HATFIELD BOROUGH PLANNING COMMISSION

**3. CORE COMMERCIAL
TEXT AMENDMENT
APPLICATION SUBMITTED
BY WB HOMES LAND
ACQUISITIONS L.P.
(41 N. MARKET STREET)**

CONCEPT LAYOUT "B3"
DEVELOPMENT STUDY EXHIBIT
41 NORTH MARKET STREET
HATFIELD BOROUGH - MONTGOMERY COUNTY - PENNSYLVANIA

Re: MCPC #26-0094-001
Proposal Name: Core Commercial District Text Amendment
Hatfield Borough

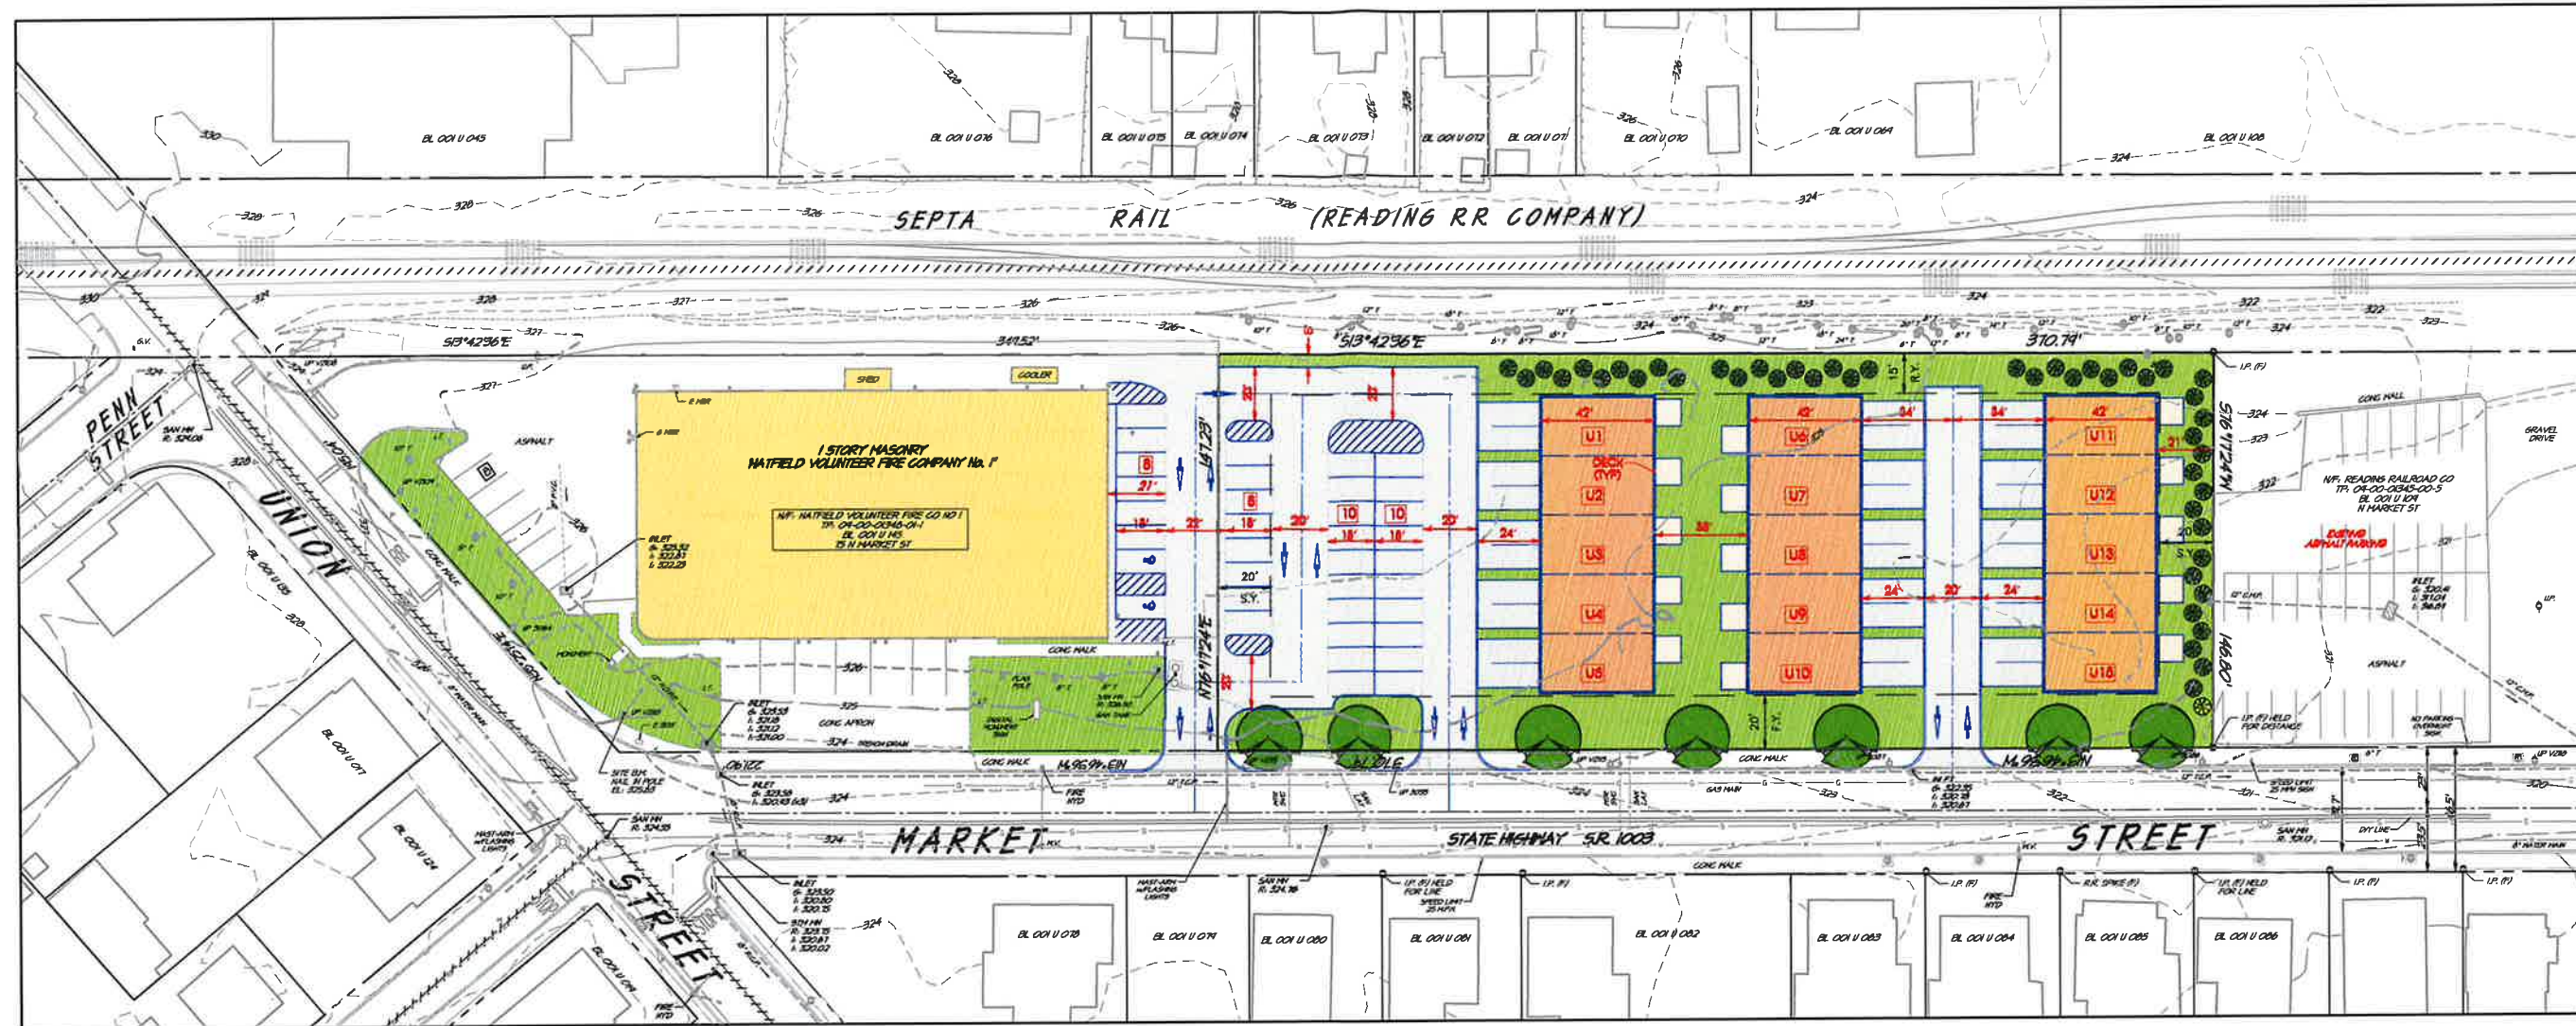
1. §27-2108.6.L Architectural Requirements. The second sentence states, "If there are conflicts between these architectural requirements and the requirements of §27-2108, the requirements shall govern." As these proposed architectural requirements are within §27-2108, this sentence is redundant and, in our view, unnecessary.

2. §27-2108.6.L.1. We recommend considering adding standards for walkways to entrance doors located within the front elevation and side elevation of residential buildings that face an existing public street. Montgomery County's Comprehensive Plan advises that new developments in a "Town Center" such as Hatfield Borough should be pedestrian-oriented with appropriate design that encourages walking. Hatfield Borough's draft 2045 Comprehensive Plan echoes the sentiment that new development in the Traditional Main Street future land use category should be pedestrian-oriented with doors that open to the sidewalk. Adding standards for walkways to entrance doors located within the front and side elevations of residential buildings facing an existing public street for any new townhouse development in the CC District will help achieve the plan's objectives and provide a necessary amenity to residents.

3. §27-2108.6.L.3. We recommend specifying that the requirements apply to side elevations of a residential building *not fronting on an existing public street* so that they are not confused with the requirements for side elevations of residential buildings fronting on an existing public street in L.1.
